# MODIFICATION OF STAGED INFRASTRUCTURE

## RESPONSE TO SUPPLEMENTARY ENVIRONMENTAL ASSESSMENT REQUIREMENTS

### 6.1 Introduction

Figure 6.3 Approved and Modified Alignments - Castle Hill Station to Norwest Station

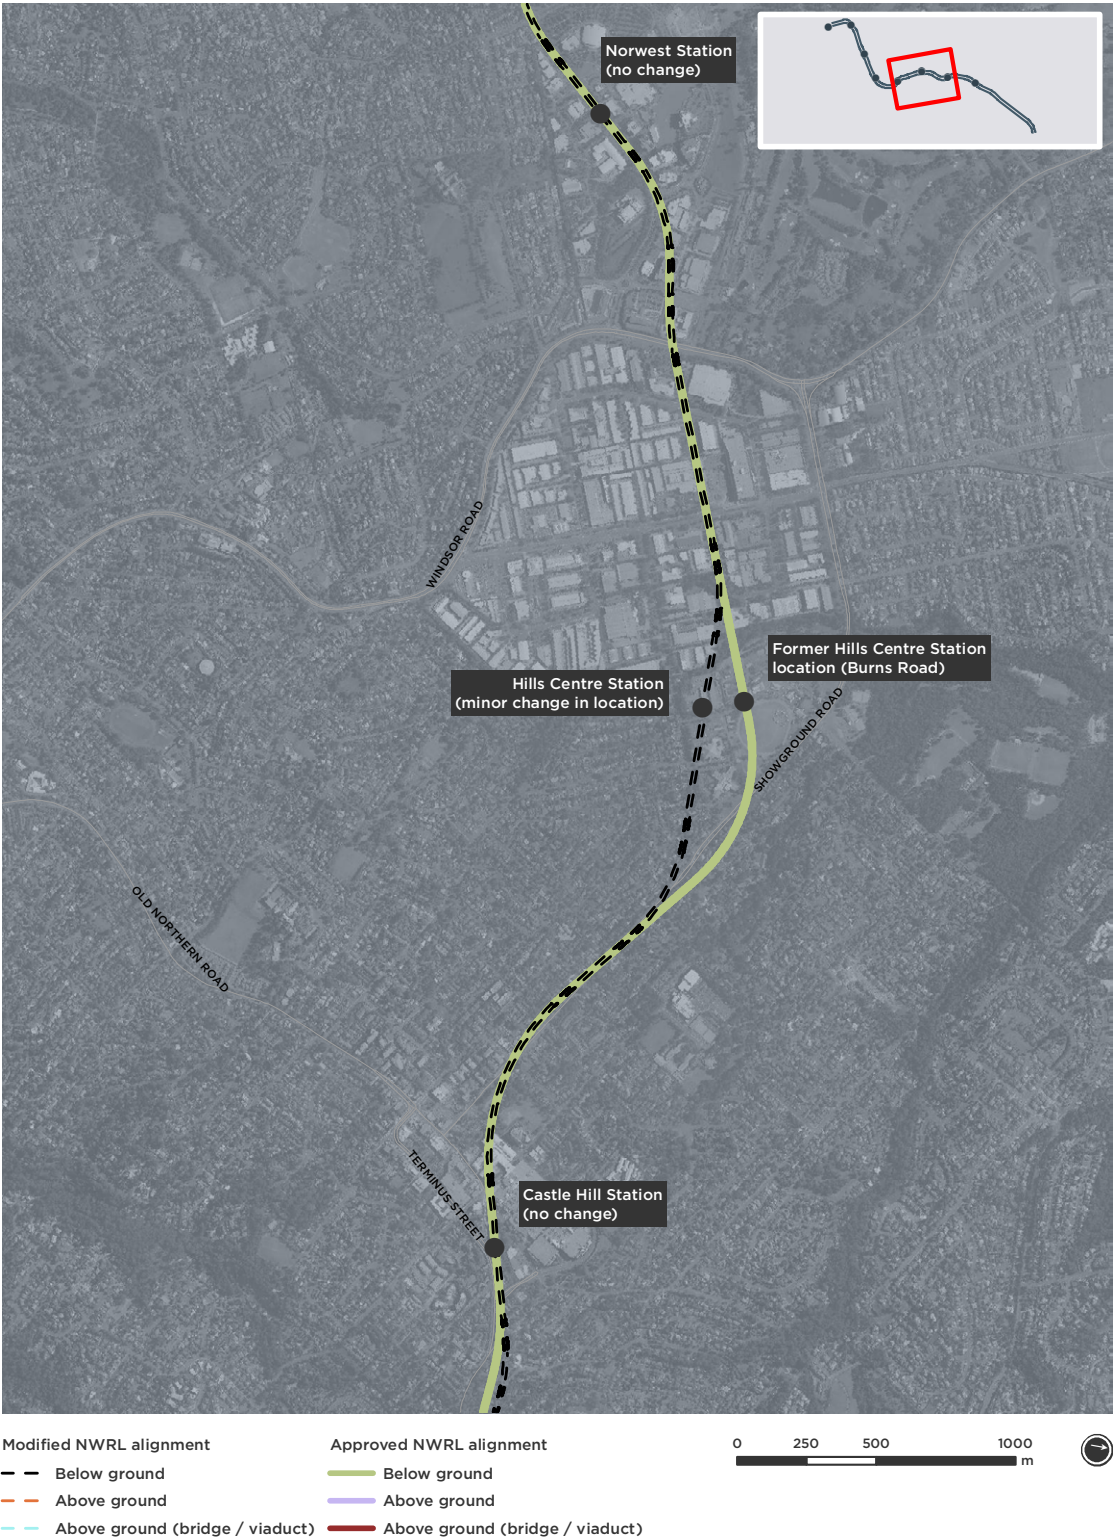
- ❖ A move to a more southern alignment for a short section between Showground Road and Carrington Road in response to the preferred southern option for the Hills Centre Station described in **Table 6.2**.
- ❖ A move to an alignment that abuts the eastern side of the North West T-way, reducing construction impacts and optimising the construction footprint in the Balmoral Road precinct.

To support the changes described above, minor changes to the horizontal alignment are required between Castle Hill and Hills Centre Stations, from the planned Bella Vista Station to the Old Windsor Road/Windsor Road intersection, and within Area 20.

Figure 6.4 Approved and Modified Alignments - Norwest Station to Kellyville Station

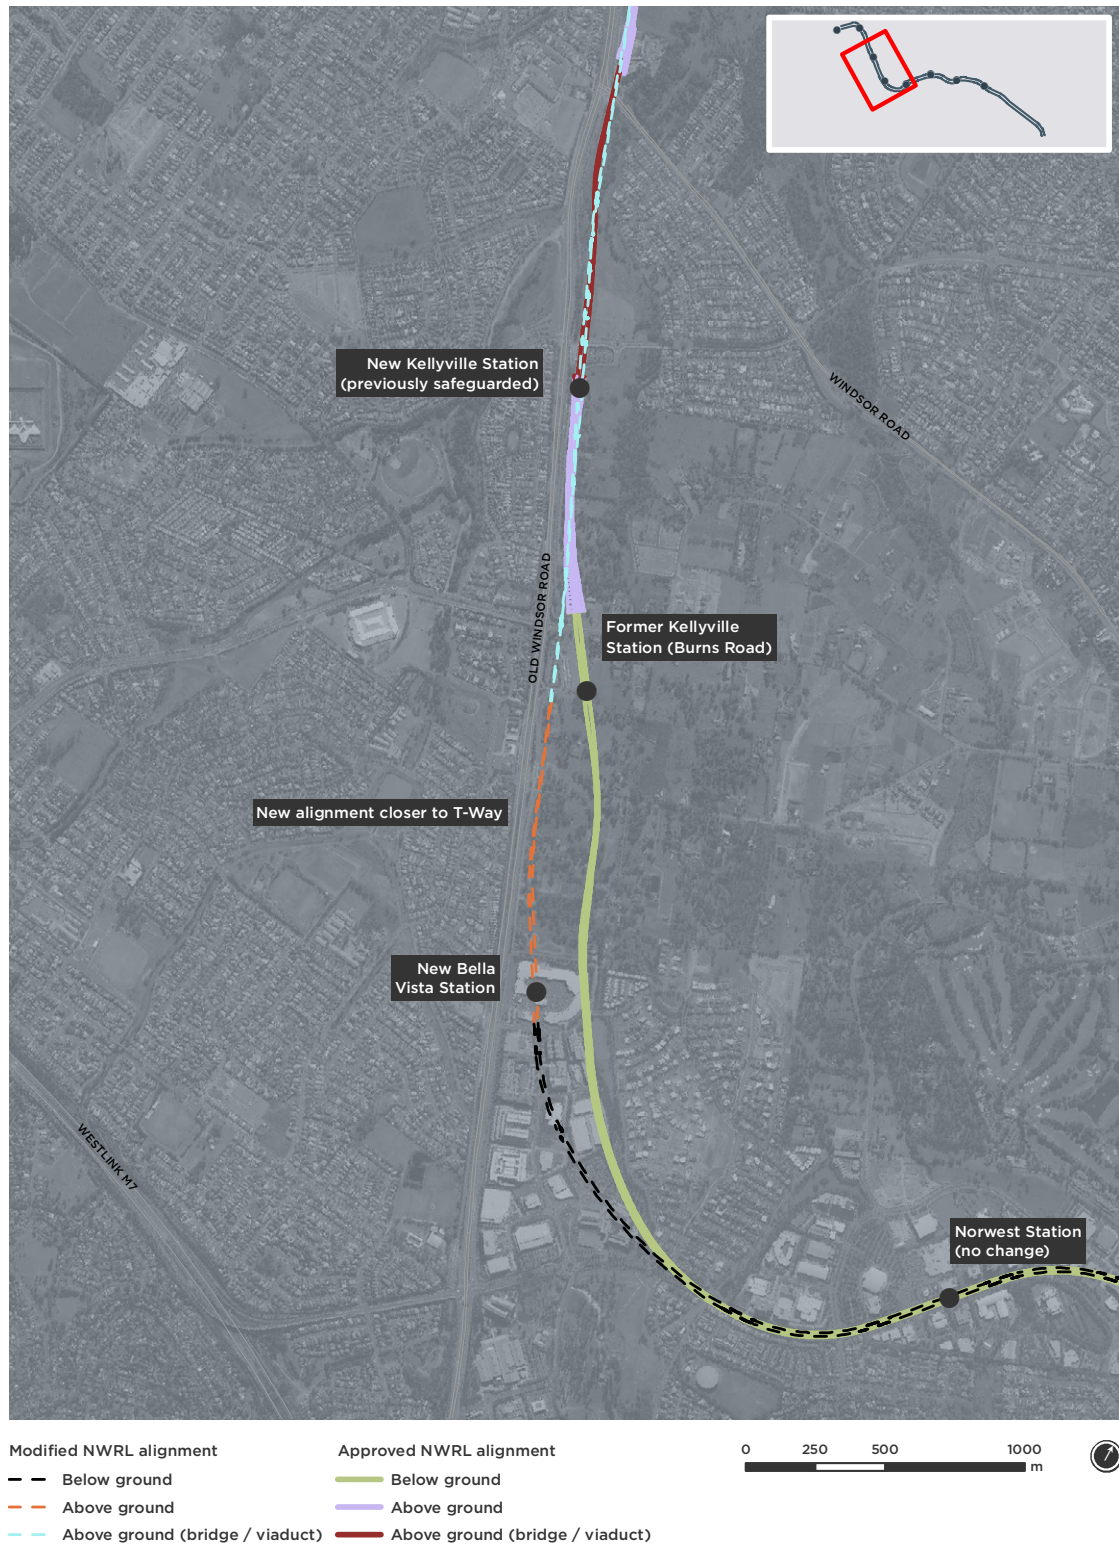
<b>Provide an additional station at Bella Vista</b>	<p><i>The 2008 concept did not provide for a second station within the Norwest Business Park.</i></p> <p>Bella Vista Station would be located on Celebration Drive, Bella Vista within the north western precinct of the Norwest Business Park.</p> <p>Bella Vista Station would be an open cut station. The station would be a combination of Park and Ride and a commercial centre destination and would provide additional public transport coverage to the western precincts of the Norwest Business Park which is identified as a Specialised Centre with a job target of 30,000 by 2036.</p> <p>Approximately 800 park and ride spaces would be provided at Bella Vista Station however numbers are being confirmed as part of the ongoing design process. Additional provision will be made for bus, taxi, kiss and ride and bicycle facilities.</p>

As noted in **Table 6.2**, there would be additional stations at Bella Vista and Cudgegong Road. From Bella Vista Station westward the alignment would rise from cutting to a viaduct following a revised alignment within land already acquired for the project. The viaduct alignment would be closer to Old Windsor Road for the section of alignment from Bella Vista to Memorial Avenue.

- ❖ The proposed change in vertical alignment between Bella Vista and Rouse Hill (approximately 4.2km viaduct) would create new land use opportunities along this section of the rail corridor.
- ❖ Change in the horizontal alignment that abuts the eastern side of the North West Transit-way would reduce the footprint required for operation of the project and increase land available for development in the Balmoral Road precinct.

Figure 6.5 Approved and Modified Alignments - Kellyville Station to Tallawong Stabling

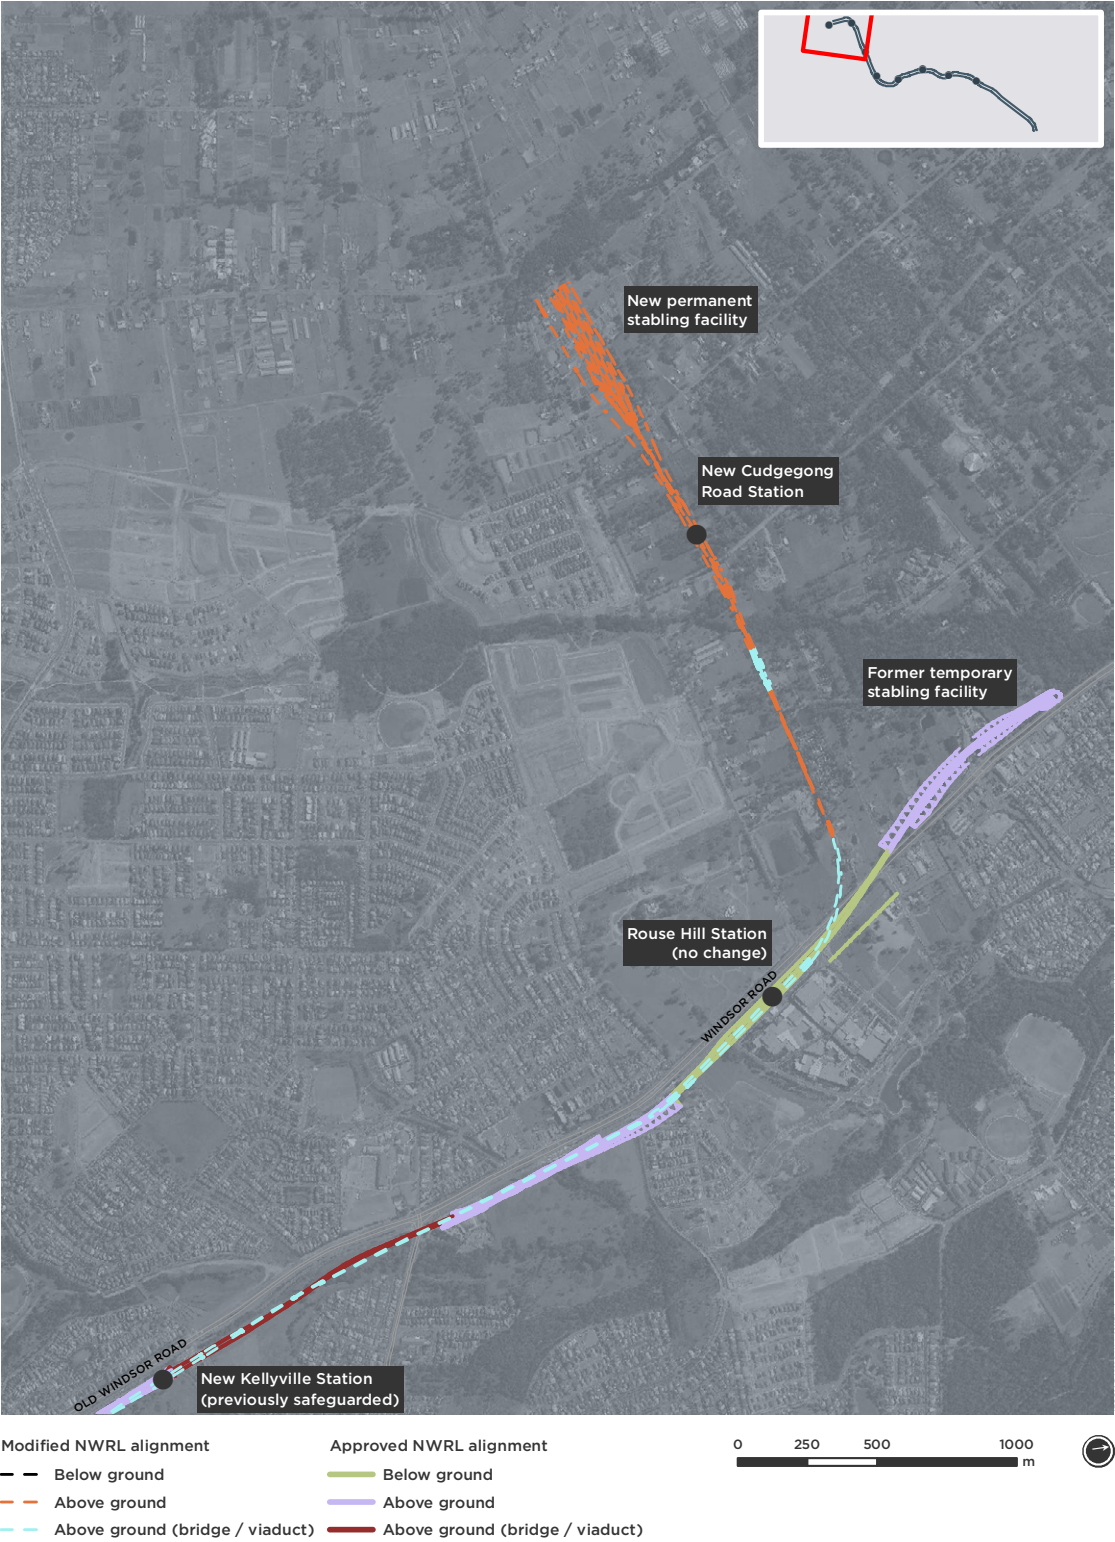
Modification	Description
<b>Relocate Kellyville Station from the vicinity of Memorial Avenue to the vicinity of Samantha Riley Drive</b>	<p><i>The Burns Road Station provided in the Staged Infrastructure Approval was located to the east of Old Windsor Road and bounded Burns Road (now Memorial Avenue) to the north and Balmoral Road to the south.</i></p> <p><i>The proposed Kellyville Station would be located south east of the intersection of Samantha Riley Drive and Old Windsor Road, Kellyville. This location was previously safeguarded as an elevated station with (unquantified) park and ride capacity.</i></p> <p>Kellyville Station would be an elevated structure and would have a Park and Ride facility to serve North Kellyville, Beaumont Hills, Stanhope Gardens and development within the North West Growth Centre.</p> <p>The station will provide approximately 1,360 park and ride spaces including 160 dedicated to the North-West T-way. Additional provision will be made for bus, taxi, kiss and ride and bicycle facilities.</p>

Following additional studies to refine the alignment of the NWRL corridor and provide certainty for new development in the North West Growth Centre, it was determined that the best route to service the North West Growth Centre is an alignment parallel to Schofields Road. A permanent stabling facility would be required at the north western end of the alignment at Tallawong Road. Refer to section 6.3.5 for details on the strategic context.

The alignment would continue on an elevated structure from Kellyville Station through Rouse Hill passing over Windsor Road before transitioning to an at-grade and open cut rail alignment through to the Tallawong stabling facility. The length of the proposed viaduct is approximately 4.2km. The modifications to the vertical alignment compared to the Staged Infrastructure Approval are summarised in **Table 6.3**.
